No: 25-110

DAUPHIN COUNTY SUBDIVISION/LAND DEVELOPMENT REVIEW REPORT

Plat Title: Minor Subdivision Plan for Mickey T. Rapp

Project Description: Consolidate existing l lots #1 and 4b# and subdivide the combine lots into 4 proposed lots.

SUBDIVISION PLAN

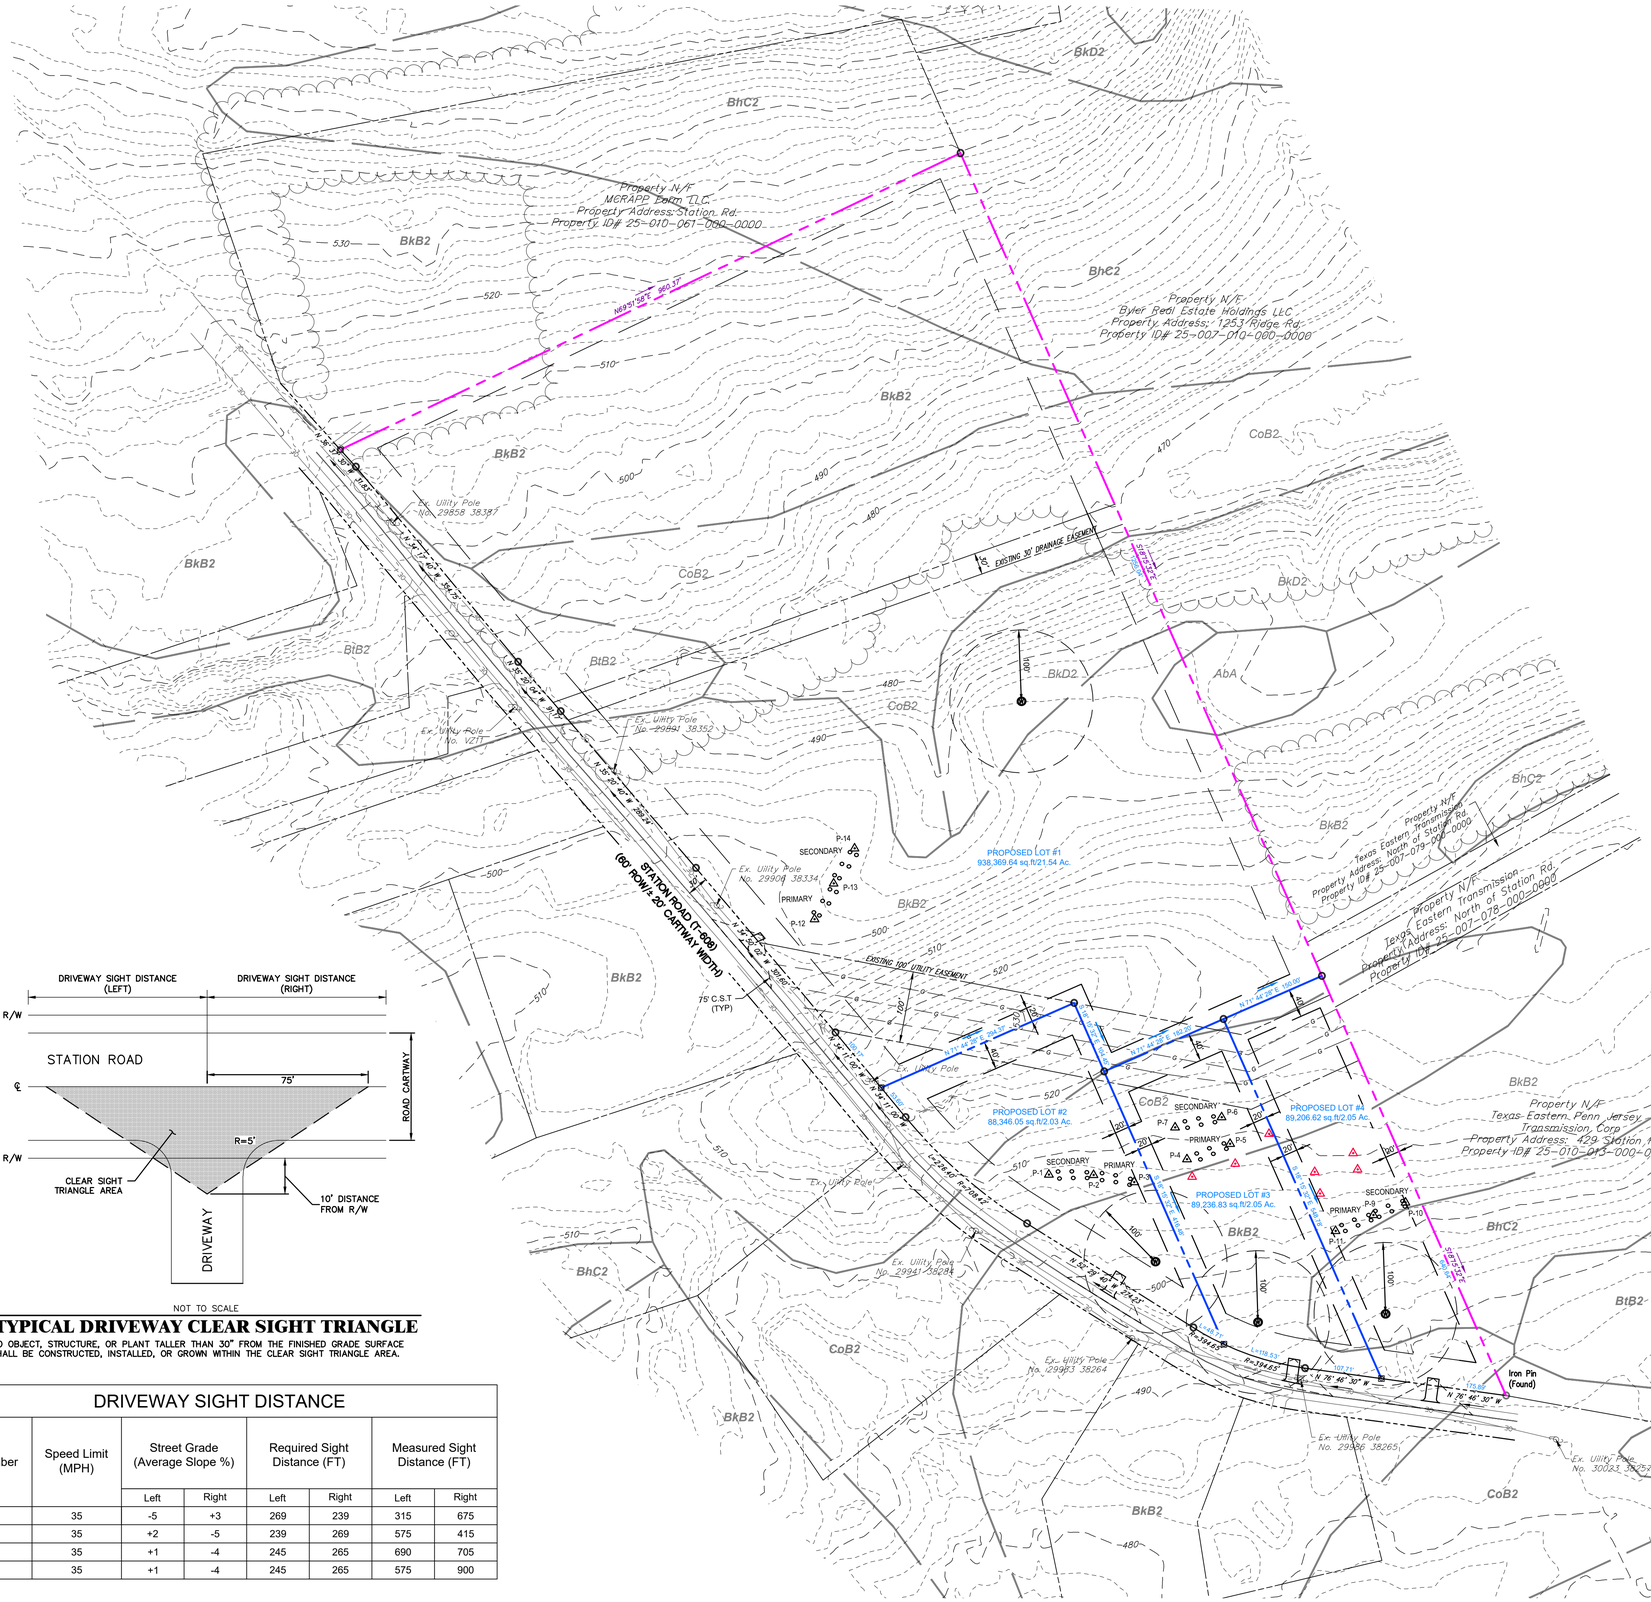
4. Clearly label the dedicated right-of-way (30' feet from the centerline of Station Road) and the 40' front yard setback as well as the existing stream that intersects parcel 25-010-061.

5. Identify any existing and/or proposed curbs. Curbs are required along collector streets and driveways according to Section 715 of the SALDO.
